SAFETY EVALUATION REPORT  
ON ENVIRONMENTAL QUALIFICATION  
OF SAFETY RELATED CABLE IN  
SURRY POWER STATION, UNITS 1 AND 2

INTRODUCTION

FIG. NO. A

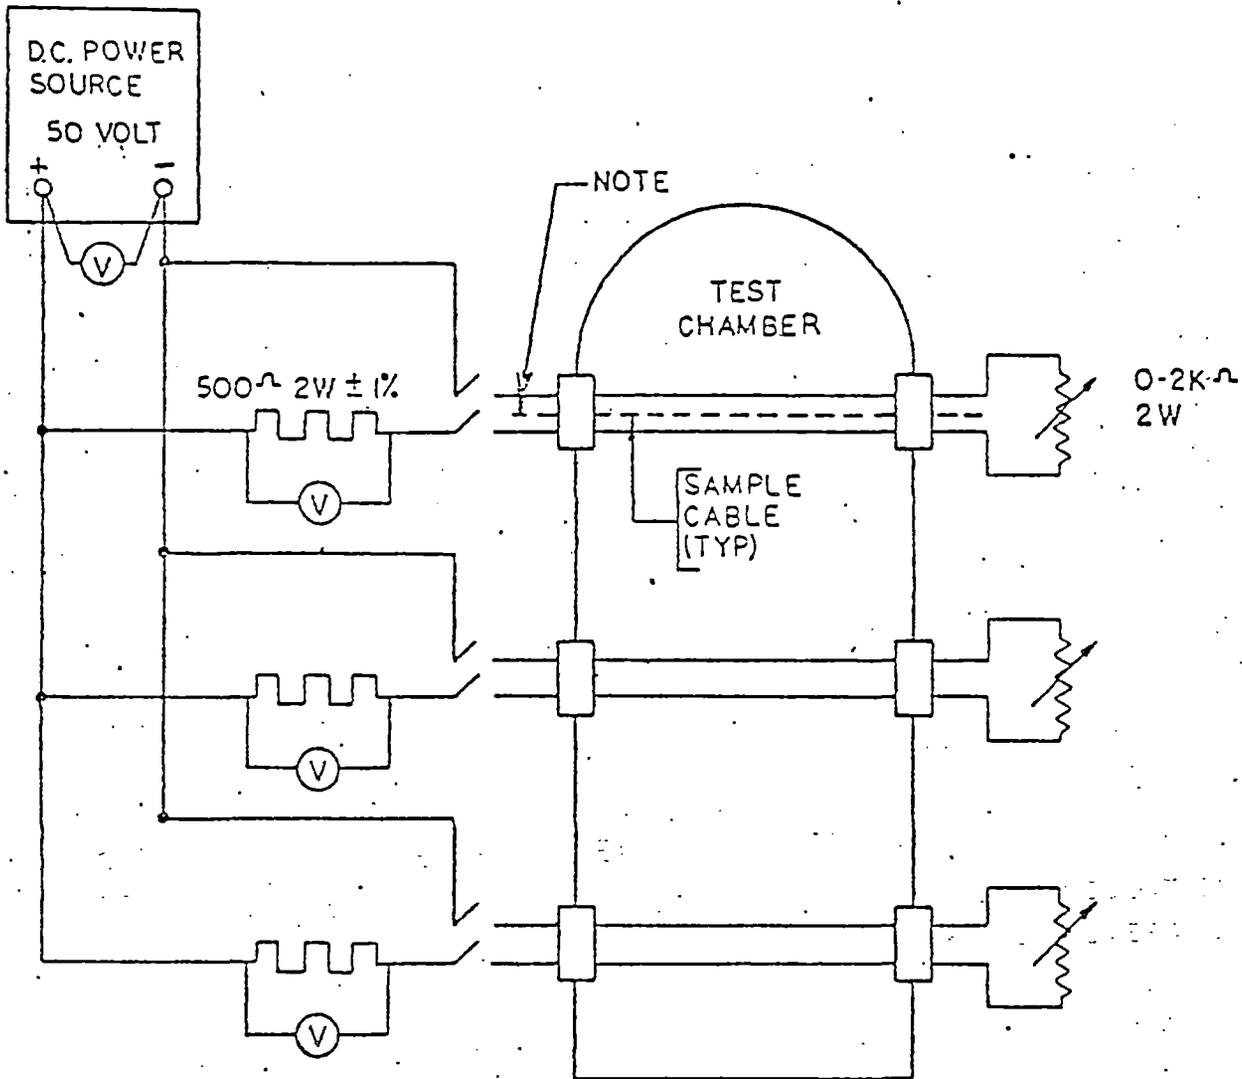
The sample cable used in the test program was 300V, two conductor, No. 16 AWG, stranded with cross-linked polyethylene insulation and hypalon jacket (see Figure A for details). The test program required seven (7) test samples to be prepared - three for the LOCA test, three for the MSLB test and one for measuring initial physical and electrical properties.

# FIGURE D

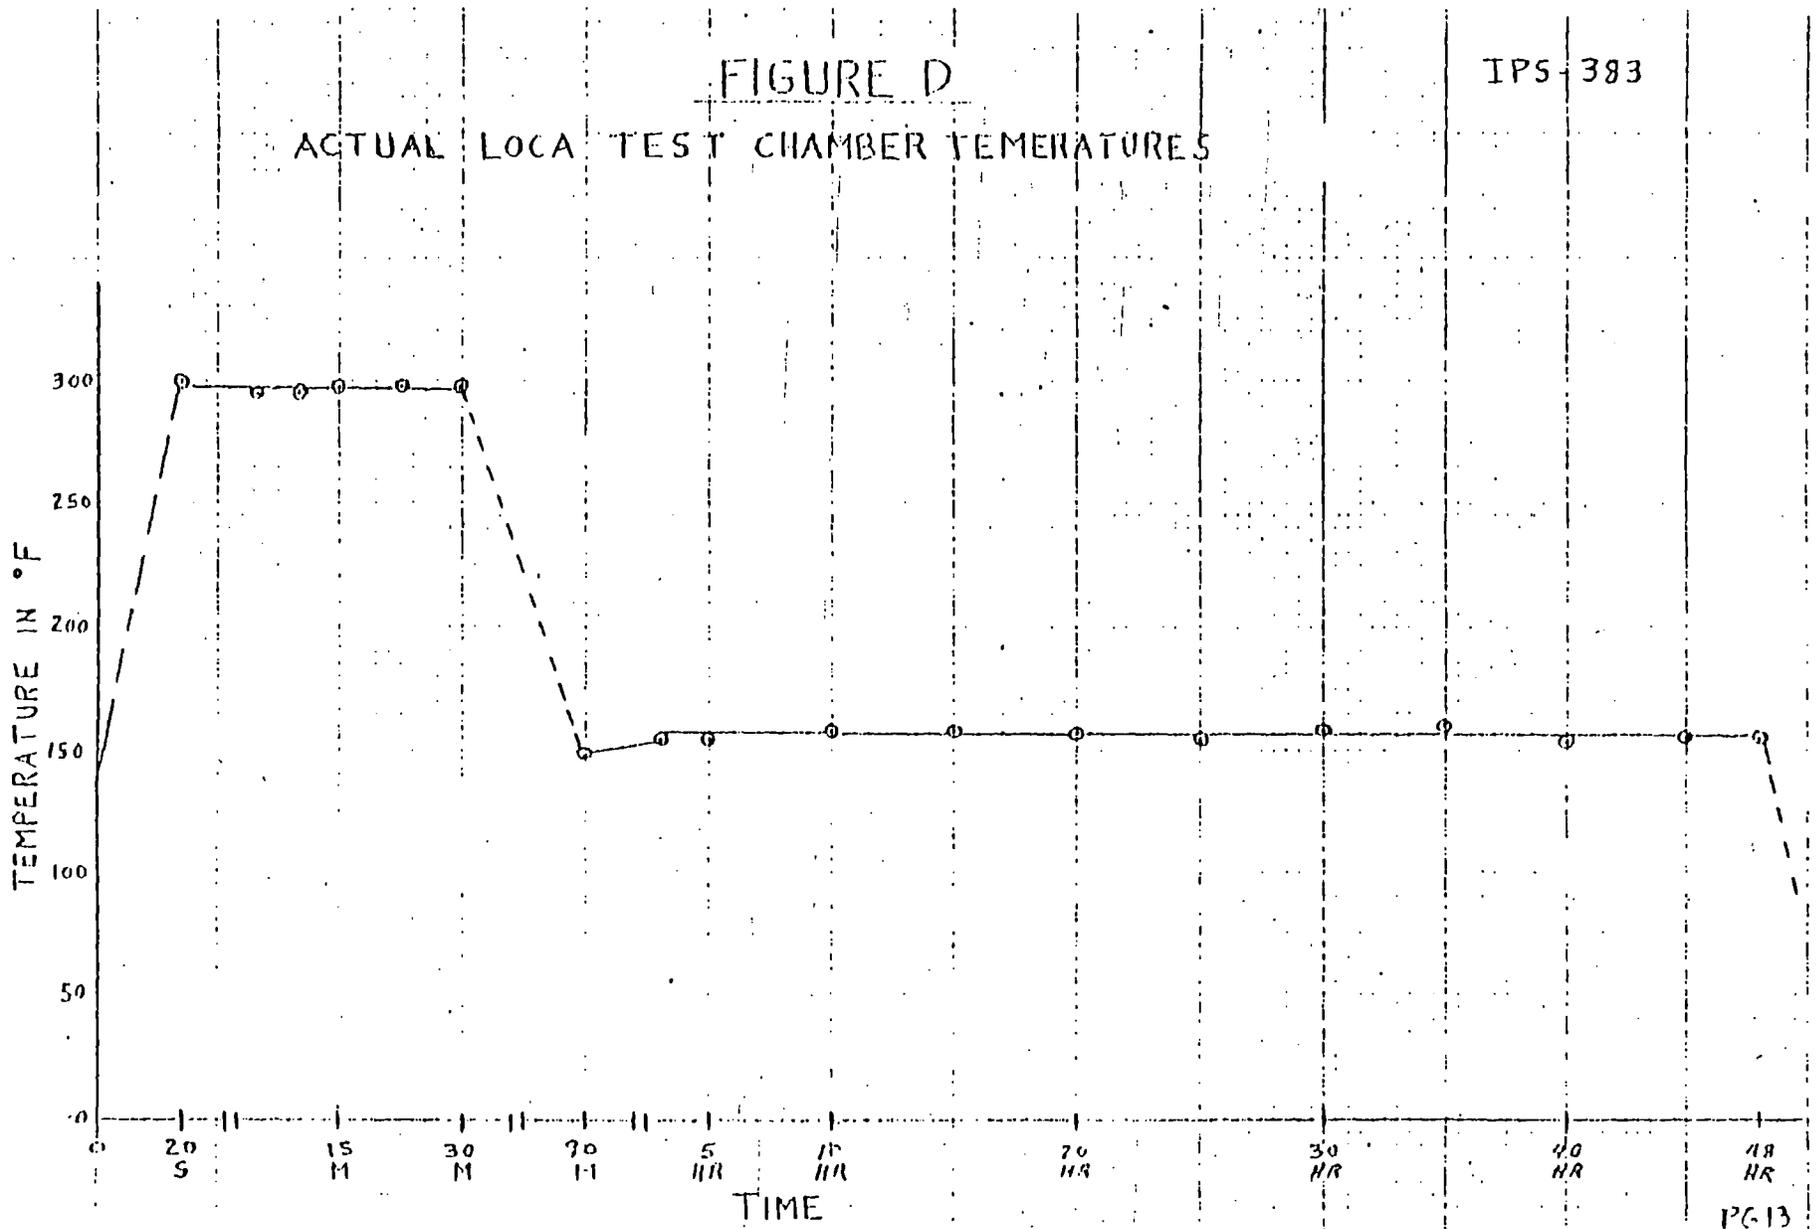
The cable samples supplied by VEPCO were cut into test samples and utilized for testing as shown in Figures B and C. These test samples that had been thermally aged for 60 hours at 100°C and irradiated to 20 MR were installed in the test chamber, connected, instrumented and subjected to the LOCA environment (temperature/pressure/chemical spray environment). The test chamber temperature profile is shown in Figure D. Data was collected

By comparing the test data and the plant's temperature and pressure profiles of LOCA and MSLB events, it was seen that adequate margin per IEEE Std. 323-1974 was provided. (The temperature peak of 420°F during 20 to 90 second interval of the incident was not obtained during the test; however, the test temperature of 350°F was sustained for a period of 15 minutes to compensate for this. This deviation was found acceptable and was approved in the test procedure itself).
